INSTRUCTION SHEET

The following information is provided as a guide for the insertion of new sheets for changes to the "Trojan Independent Spent Fuel Storage Installation Safety Analysis Report," dated November 25, 1996

FIGURE 4.2-6a
FUEL DEBRIS PROCESS CAN

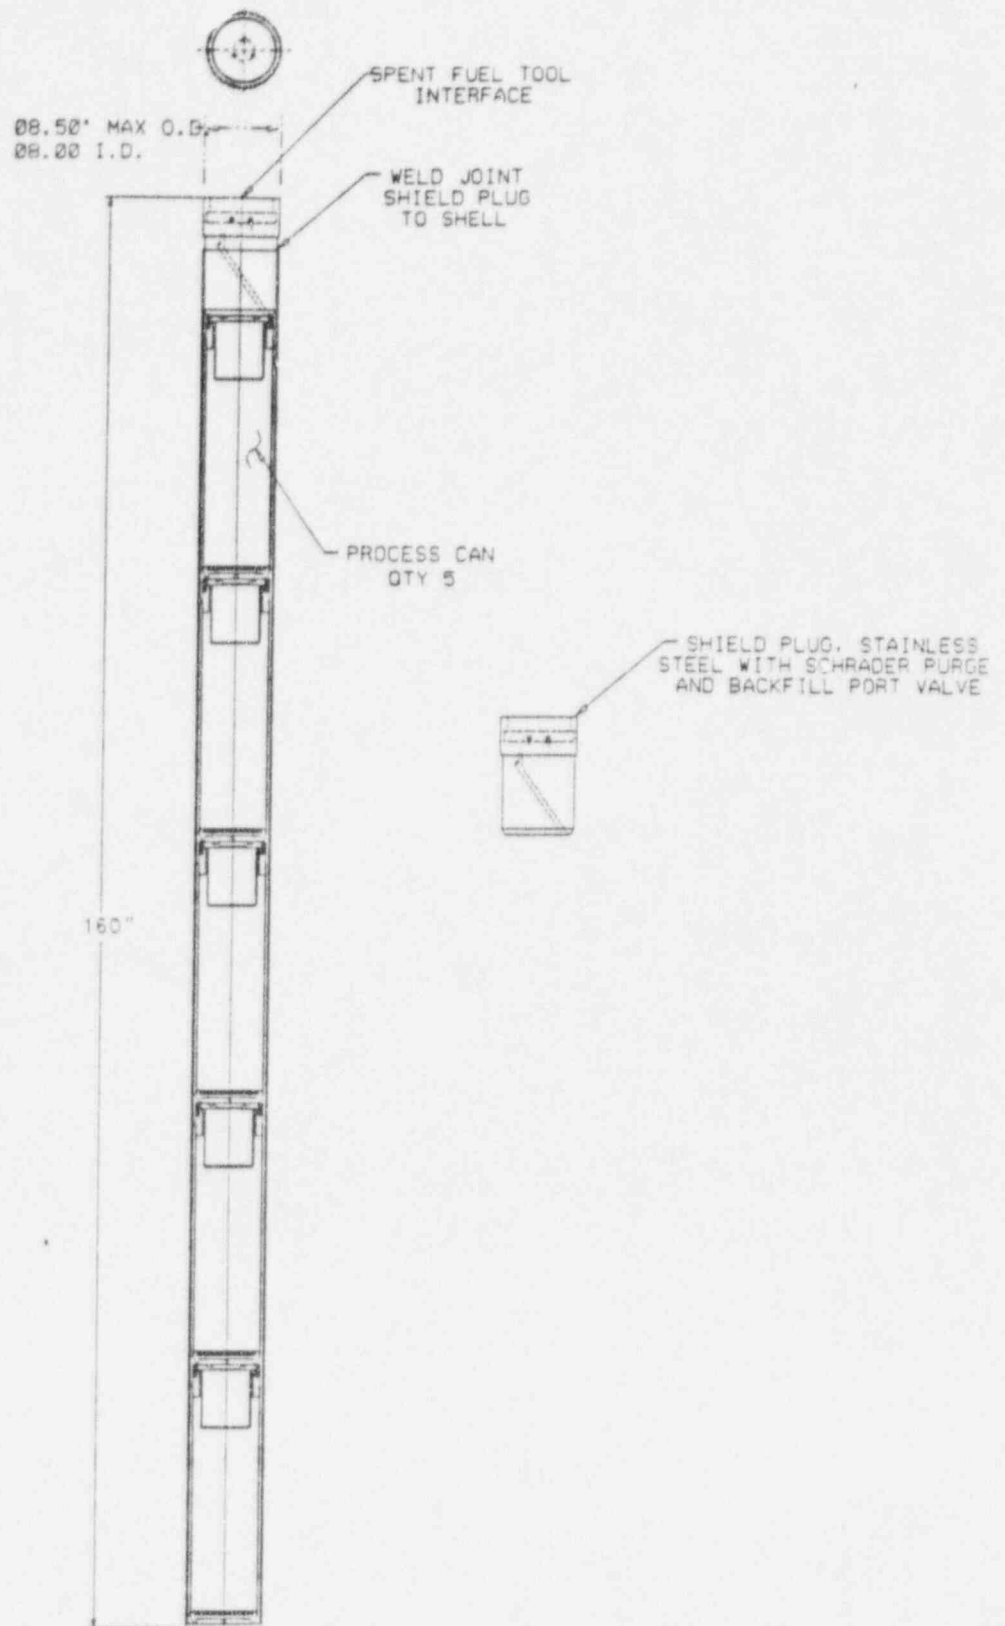
Table 4.2-1a
Figure 4.2-6

Table 4.2-1a
Figures 4.2-6a and 4.2-6b

The process can, shown in Figure 4.2-6a, is the container used to process the organic media and fuel debris located in the Spent Fuel Pool. The process can is constructed of 300 series stainless steel for corrosion resistance. The process can has 5 micron metallic filters in both the can bottom and lid. These filters allow removal of water and organic media by high temperature steam, while retaining the solid residue from the processed media and fuel debris inside the process can.

After high temperature steam processing, up to five (5) process cans are placed inside the process can capsule shown in Figure 4.2-6b. The process can capsule is constructed of 304 stainless steel for corrosion resistance and is inerted with helium. The process can capsule provides a sealed containment for the fuel debris. The process can capsule is designed to be lifted by normal fuel handling tools.
